**MONTGOMERY COUNTY HISTORIC PRESERVATION COMMISSION**  
**STAFF REPORT**

<b>Address:</b>	5419 Mohican Rd., Bethesda	<b>Meeting Date:</b>	4/23/2025
<b>Resource:</b>	Master Plan Site 35/29-2 <b>R.A. Charles Castle</b>	<b>Report Date:</b>	4/16/2025
		<b>Public Notice:</b>	4/9/2025
<b>Review:</b>	HAWP	<b>Tax Credit:</b>	n/a
<b>Case Number:</b>	1110102 and 1111619 RETROACTIVE	<b>Staff:</b>	Dan Bruechert
<b>Proposal:</b>	After the fact alterations to building details, fenestration, chimney, site grading, and other alterations

The applicant seeks retroactive approval for alterations to building details, fenestration, chimney, site grading, and other alterations.

Figure 4: Approved West Elevation.

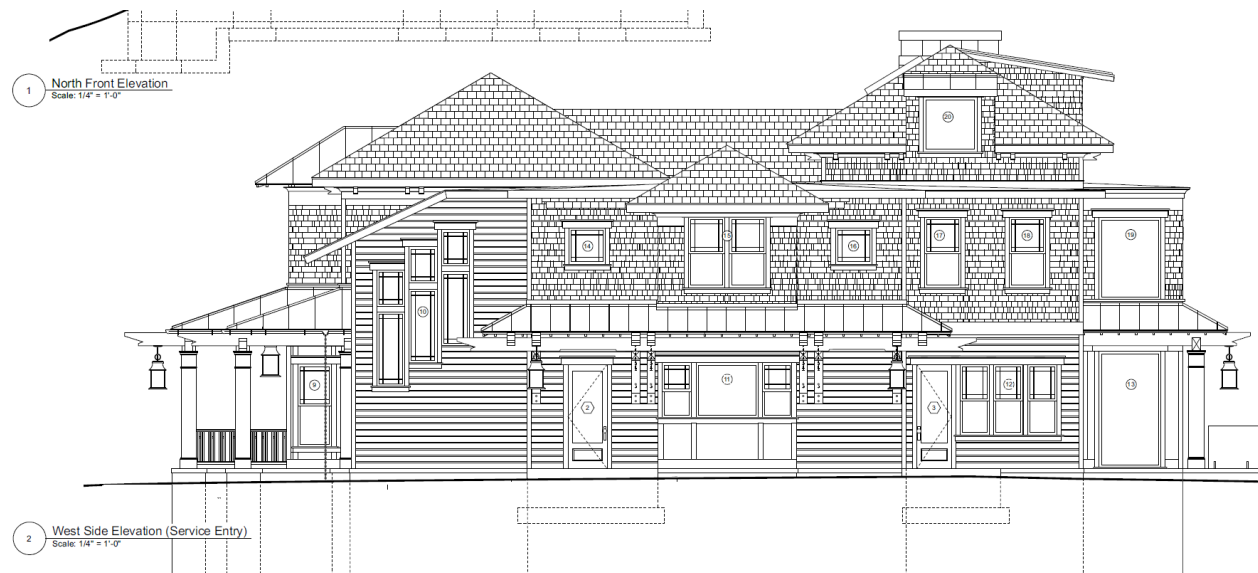
- Steeper pitched rooflines;
- Selections of fiber cement siding replaced with fiber cement clapboards;
- Stone veneer foundation removed and replaced with fiber cement siding;
- Columns eliminated and bracketed porch overhang installed;
- Dormer enlarged and located to align with wall plane.

- Ground floor window converted to a door;
- Central ground floor window assembly size reduced;
- Ground floor window to the right of the central window assembly removed;
- Single sash window replaced with a tripled sash window assembly; and
- Enlarged window in projecting bay.

- All window sizes revised;
- Casement windows on right side converted from casements to sash windows; and

- Casement window in projecting bay revised to a single-light picture window.

Figure 6: South Elevation (approved design).

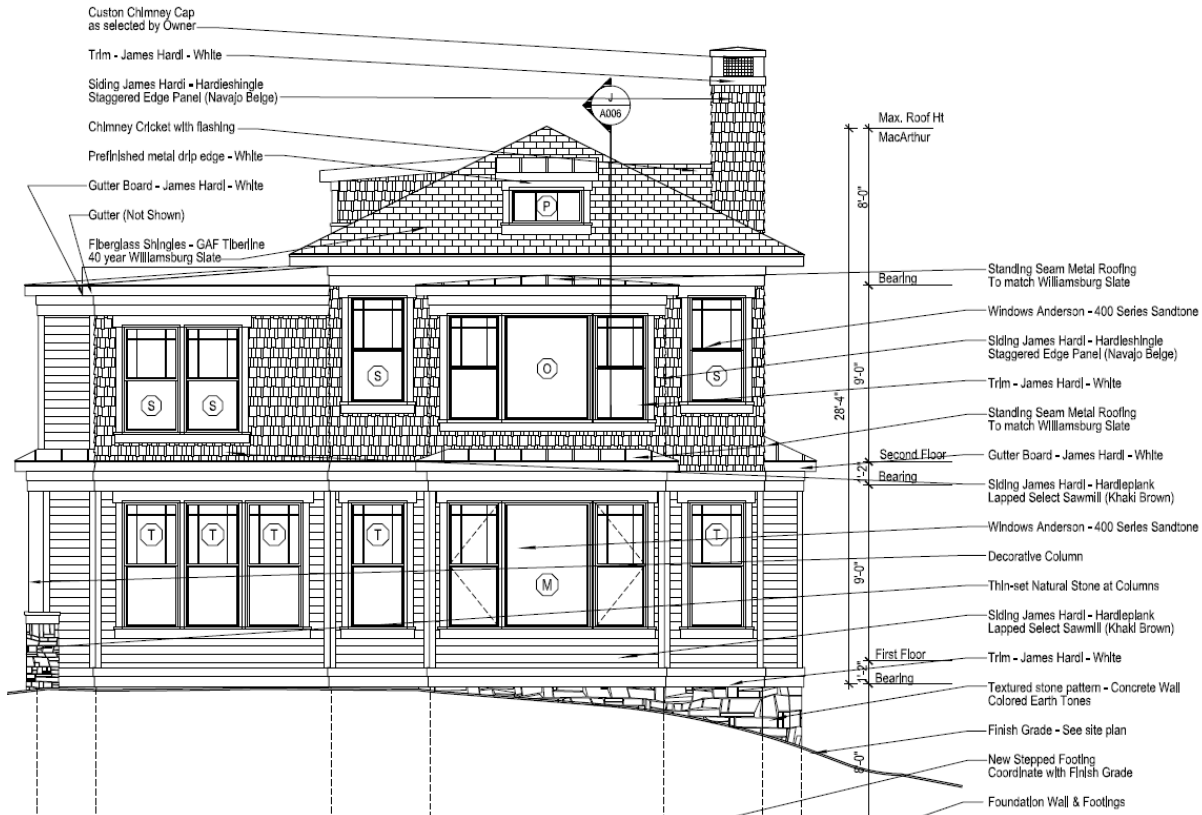
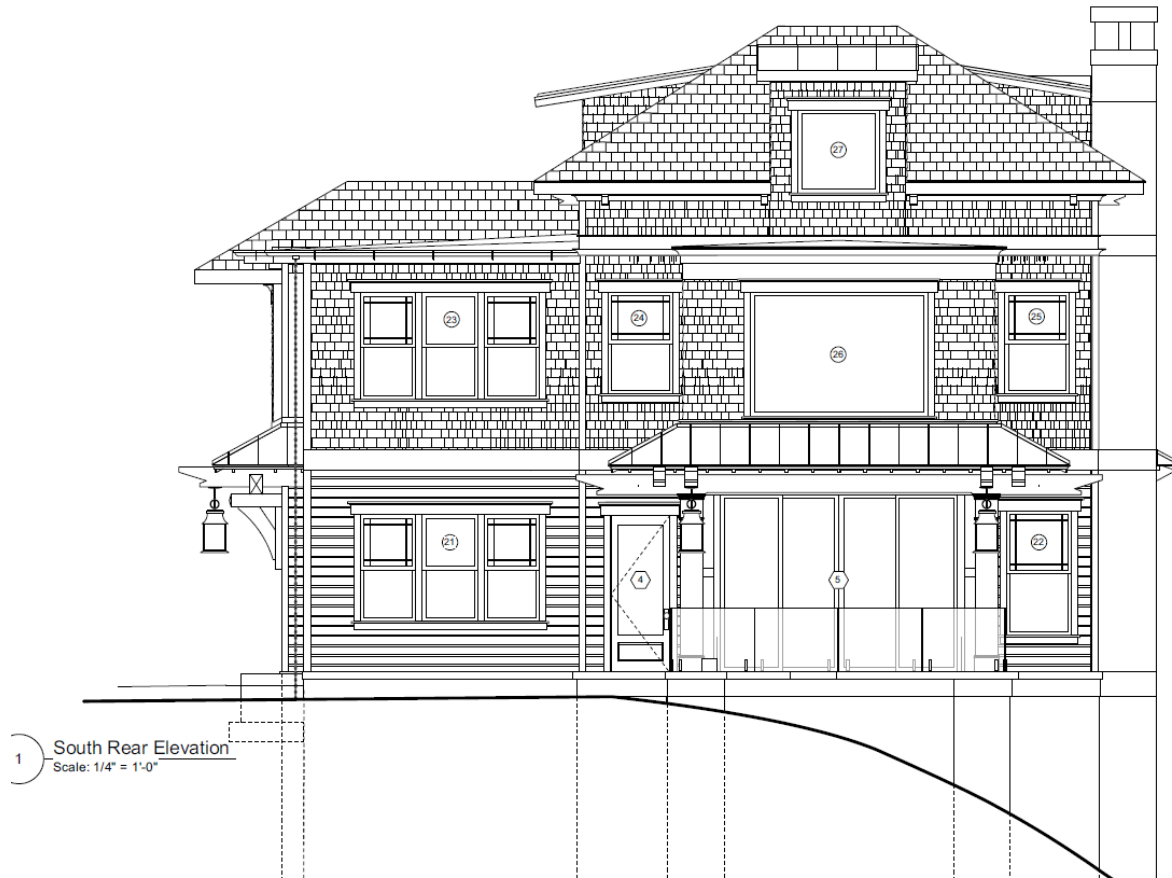
- Roof pitches altered;
- The bandboard and cornice were simplified;
- The dormer was enlarged and it was moved closer to the south wall plane;
- The dormer window was converted from a rectangular three-light casement to a square picture window;
- A patio with a glass railing was installed in front of the projecting bay; and
- Grade drops off to east, exposing more of the foundation.

- The window assembly on the left removed the Craftsman grilles and installed a one-over-one sash window in the central window;
- The window in the middle bay was eliminated and the opening was converted to a full-light door;
- The Chicago window assembly in the projecting bay was eliminated in the opening was converted into full-light accordion doors.

- The paired window on the left side was converted into a tripled window assembly;
- The Chicago window in the projecting bay was converted into a large square picture window;
- The hipped roof over the projecting bay was lowered and covered with a membrane roof instead of the approved metal roof.

Figure 10: West elevation submitted in the 2020 HAWP application.

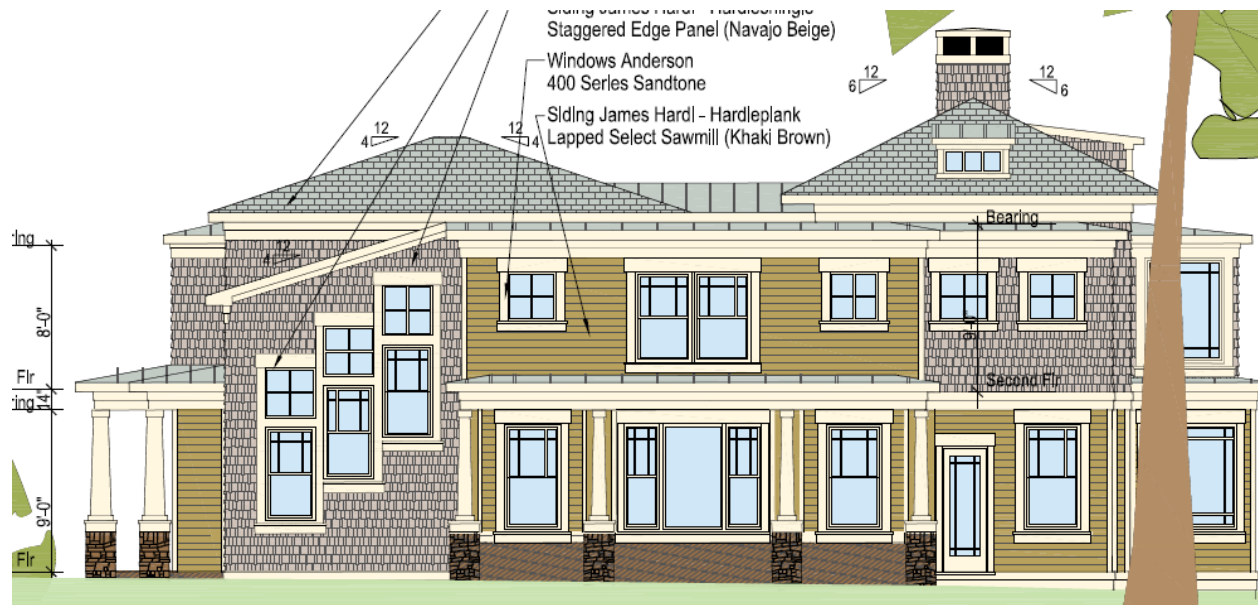
Lastly, Staff feels it is appropriate to address something the HPC tends to avoid: paint color. The approved HAWP (see *Fig. 10*, below) proposed two colors of siding, Navajo Beige for the shakes and

Kaki Brown for the clapboards. The approved permit documents identified the same colors for the siding. Staff found these earthtones would better blend in with the stone construction of the R.A. Charles Castle and its neighboring Master Plan Site, the Baltzley Castle.

However, based on the results of this HAWP Staff encourages the HPC's reconsideration of this practice. The subject house was constructed with white siding and black windows and doors. As of this Staff Report this palette is very popular. The R.A. Charles Castle was constructed using rusticated granite with a red slate roof. These natural colors have the effect of blending in with the surrounding landscape. As shown in *Figure 11*, the white house stands apart rather than blends into the background. Staff finds the infill garage,<sup>3</sup> constructed in the colors approved for the subject property, does a better job of being a compatible piece of the overall character of the site while still being differentiated from the stone castle.

As with the other deviation from the approval documents, Staff does not find repainting warranted under 24A-8(b)(5) but brings up this issue for the HPC's consideration in future decision making.

*Figure 13: The existing site conditions with the section of grade that must be reduced in slope.*

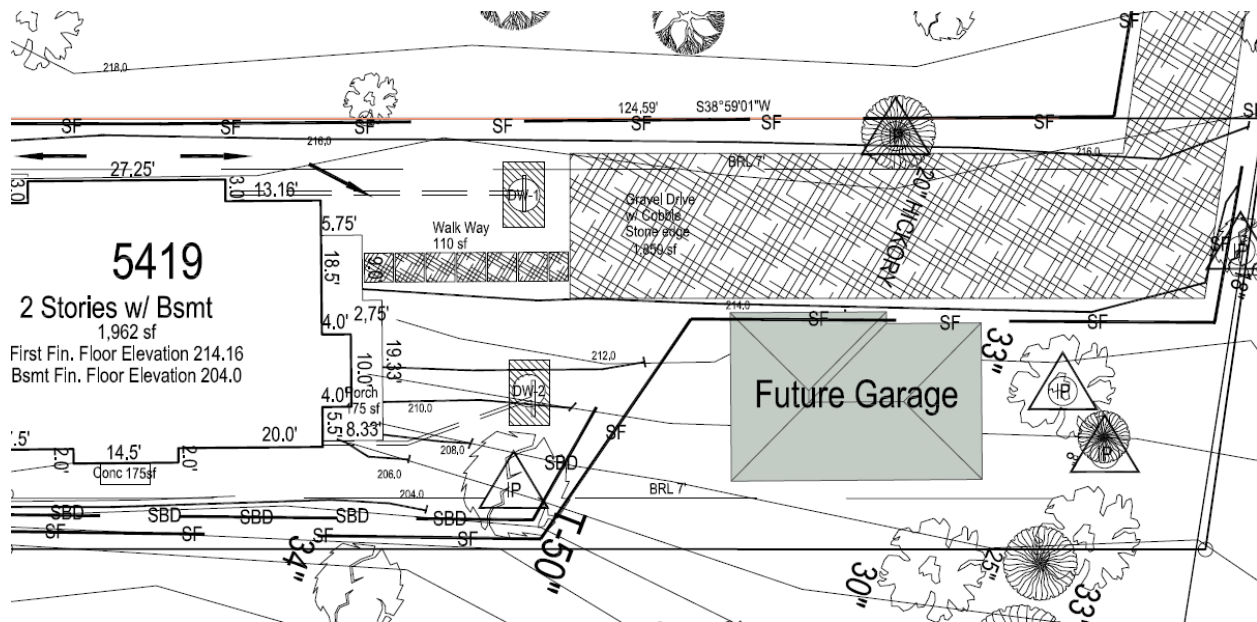
To the south of the house, the applicant proposes to soften the grade to satisfy the 3:1 requirement for the sediment control permit. The current grade is a result of moving the excavated ground to the south (see *Figure 13*, below). Staff finds the current condition is much steeper than the natural grade on the neighboring Master Plan Sites and that regrading the subject property will only improve its compatibility. Staff additionally finds that with the addition of the trees on the site and the heavily planted condition of the Master Plan Site, the grade alteration will likely have no significant visual impact on the character of the site. Furthermore, the change to the grade will reduce soil erosion and reduce water runoff from the subject property, reducing the impact to the county's stormwater system. Staff recommends the HPC approve the regrading under 24A-8(b)(2) and (6).
